TECHNICAL NOTE: DAVIDSTOW EPR ADDENDUM

DATE:	11 April 2023	CONFIDENTIALITY:	Confidential
SUBJECT:	Addendum to EPR/BN6137IK/V011		
PROJECT:	Davidstow EPR Variation Application	AUTHOR:	Karen Phillipson
CHECKED:	Charlotte Daniels	APPROVED:	Karen Phillipson

2.1 Creamery Project No.4 Whey Protein Concentrate (WPC35 → WPC60)

Figure 2-1 – Creamery Production Processes (updated to incorporate WPC60)

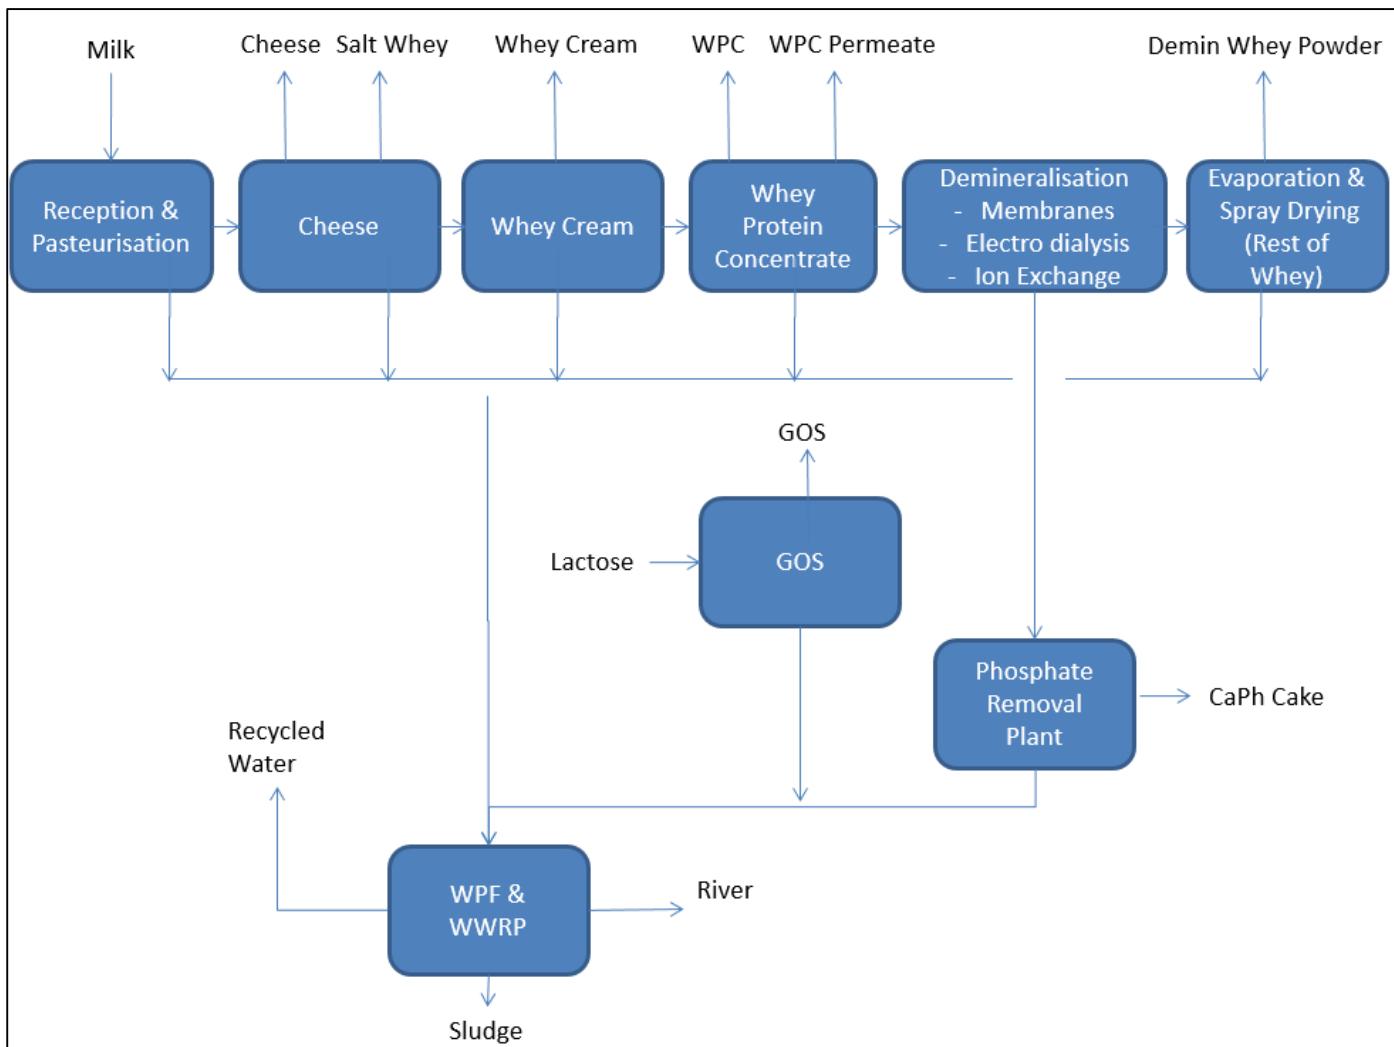
The modified WPC35 plant will concentrate the whey stream and produce WPC60 either for protein management of infant formula powder or for export as a separate value stream which can be used by 3rd party food manufacturers in high protein products. Permeate from the WPC60 membranes will be treated further to create whey concentrate and water. The whey concentrate will be exported to food manufacturers or anaerobic digestion plants.

Water generated from the concentration of whey in the WPC60 process will be polished and re-used to clean the WPC60 equipment. An updated version of Figure 4-1 (Creamery Production Processes) included in the 2022 Variation Application is provided in Figure 2-1 below to reflect these changes, i.e. the additional WPC60 export stream.

Figure 2-2 – WPC60 Equipment Layout (Adjacent to Existing Demineralised Whey Process Area)

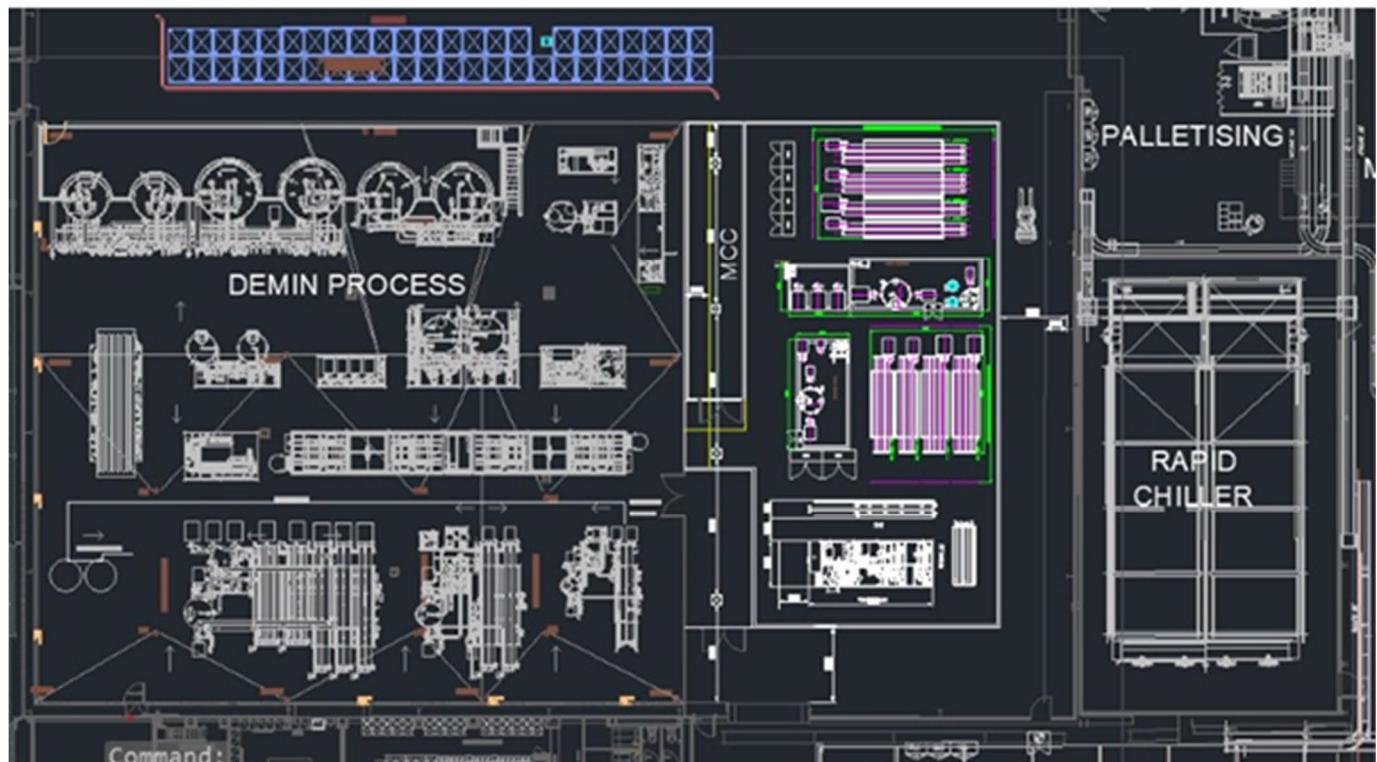
The new membrane and pasteurising equipment associated with this project will be located adjacent to the D90 process area building in a new process room. The layout of the new equipment and infrastructure is shown in Figure 2-2 below and Figure 2-3 provides a process flow diagram which shows the WPC60 process. The WPC60 processing plant is expected to be installed and operational by Autumn 2024.

Implementation of the WPC60 project requires the installation of the following additional equipment and infrastructure (as shown in orange in Figure 2-2 above):

- 1 x 225,000 litre raw whey storage silo;
- 1 x 45,000 litre/hr whey pasteuriser;
- 1 x 50,000 litre pasteurised whey buffer tank;
- 1 x 45,000 litre/hr NF membrane plant;
- 1 x 45,000 litre/hr NF/RO/ROP membrane plant;
- 2 x 50,000 litre re-purposed WPC60 storage silos;
- 2 x 200,000 litre concentrated permeate silos; and
- 2 x 200,000 litre polished RO water silos.

Figure 2-3 – Process Flow Diagram Showing WPC60 Process

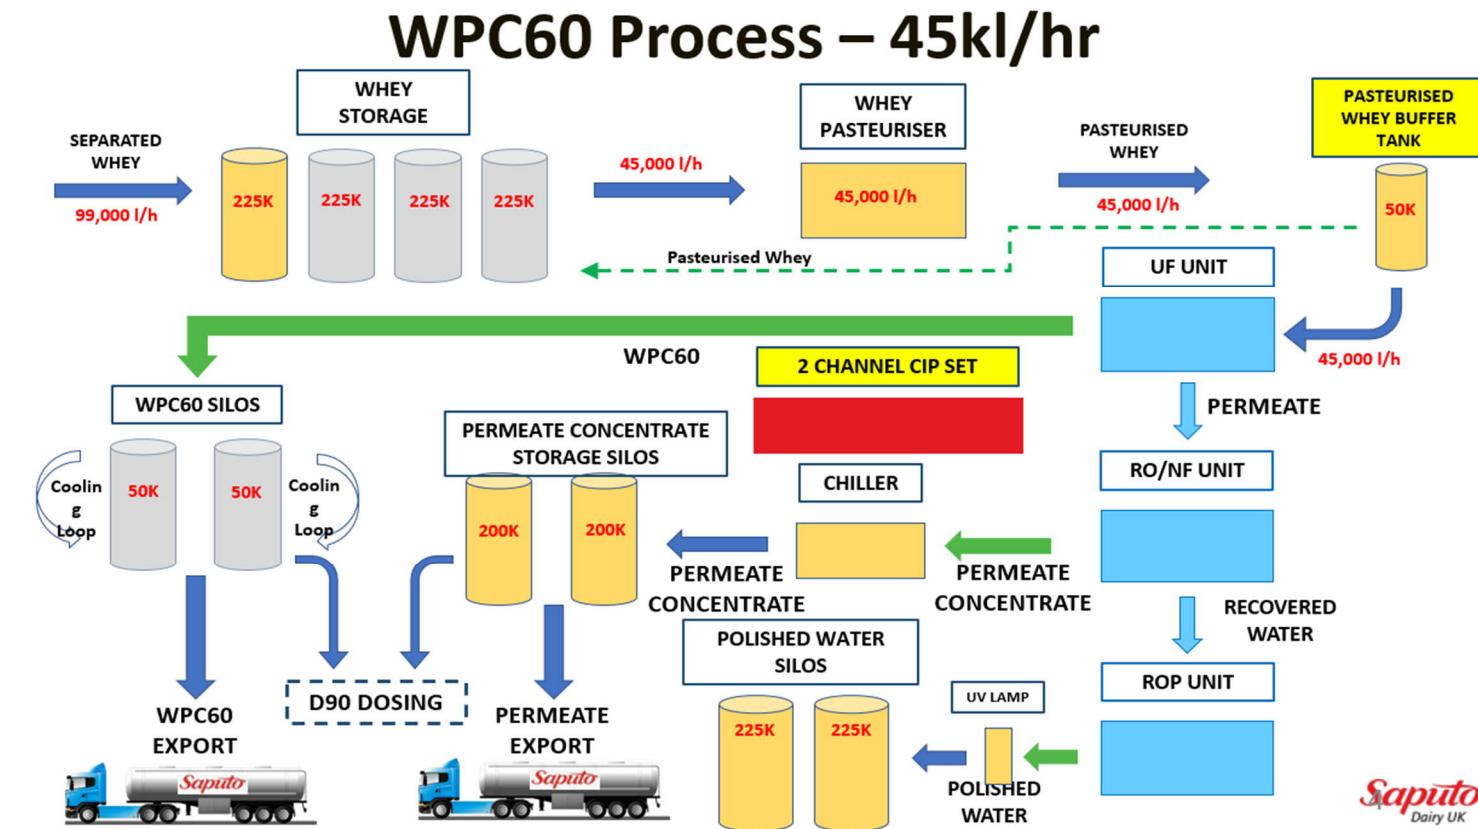
The WPC60 plant requires an additional whey storage silo to feed whey into the process. The whey will be heat treated through a whey pasteuriser and held in a buffer silo before going forward into membrane processing. The first membrane processing stage is nano-filtration (NF) where the whey is split into two product streams, retentate (concentrated whey proteins) and permeate (the remaining whey constituents such as water, lactose and minerals).

The permeate will be processed through a second stage of membrane processing using nano-filtration, reverse osmosis and water polishing (NF/RO/ROP). The NF removes any remaining protein and solids into

The permeate stream is then concentrated using the RO membranes with the removed water cleaned for re-use through the ROP. Concentrated permeate will be stored in two silos for re-use within the D90 powder process or export by road tanker to third parties.

Figure 2-5 – Anoxic Tanks AN2 and AN3 Before and After Installation of Cover

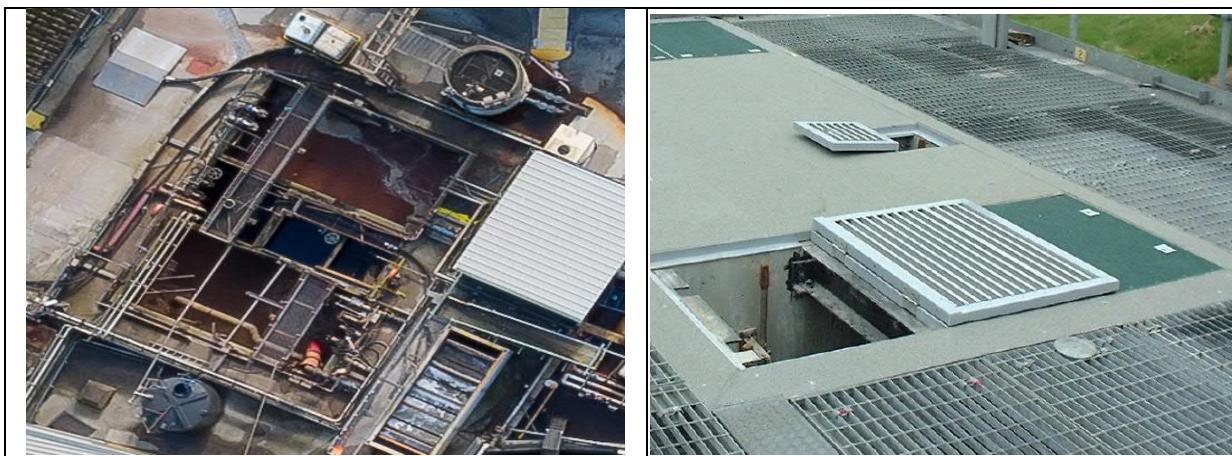
Ongoing olfactometric assessment, since submission of the 2022 Variation Application, has shown the next greatest contribution to residual odorous emissions to be Balance Tank 2 (BT2) which receives DAF treated effluent from BT1, and the two Anoxic Tanks AN2 and AN3. Although the emissions of odour per m² from BT2 are not significant, the surface area of BT2 adds to the magnitude of potential emissions. Therefore, in order to further reduce the potential for offsite odour emissions, as agreed in recent discussions with the Environment Agency, it is planned to install covers, extraction and abatement via a new OCU (designated Release Point A12) from BT2, AN2 and AN3. For completeness, the existing building housing DAF2 will also be extracted to the new OCU to benefit the working environment in that building. The project details are summarised in Table 2-5 below and photographs of the tanks before and after the envisaged covers are installed are shown in Figures 2-4 and 2-5.

Change / Improvement	Description and Benefits
Covering and extraction of BT2, AN2 and AN3	<p>BT1, AN2 and AN3 will be covered with Glass Reinforced Plastic (GRP) lids (BT2: non-walk-on cover and AN2/AN3: walk-on cover) and the air displaced from the covered headspace of the tanks will be treated via an OCU, in order to minimise odours, before discharge to atmosphere.</p> <p>The new OCU will comprise a single stage, dry chemical scrubber consisting of Diox and Triox media which remove H₂S (the principal odorous compound present) and other odours respectively. The scrubber is designed to achieve 99% removal of H₂S and 90 % of overall odours routed to the OCU. Based on average measured odour emission rates from 2019 to 2022, this represents a reduction of over 40% of the residual odour emissions from the WPF as a whole.</p> <p>An induced draught fan will draw treated air through the OCU at a rate of approximately 1,400 m³/hour (TBC – subject to detailed design). The fan will be sized sufficiently to accommodate maximum tank fill rate and aeration air added to BT2 whilst maintaining a slight negative pressure in the associated tanks and building. The fan will discharge treated air to atmosphere via a 6 m exhaust stack. The new OCU and exhaust stack (Release Point A12) will be located on top of the new load bearing covers over anoxic tanks AN2 and AN3.</p> <p>The Odour Impact Assessment submitted as part of the 2022 Variation Application included BT2, AN2 and AN3 as area emission sources and, therefore, this assessment is still considered to be valid. However, it provides a conservative assessment as, once these sources are covered, extracted and abated via the new OCU, the emissions and hence the environmental risk will be reduced even further.</p> <p>The new OCU (Release Point A12) associated with this project will be monitored in accordance with the monitoring arrangements specified in Table 5-1 (Monitoring Arrangements) of the 2022 Variation Application.</p> <p>This project is expected to be completed by December 2023 and is being expedited to achieve the associated reduction in odour emissions.</p>
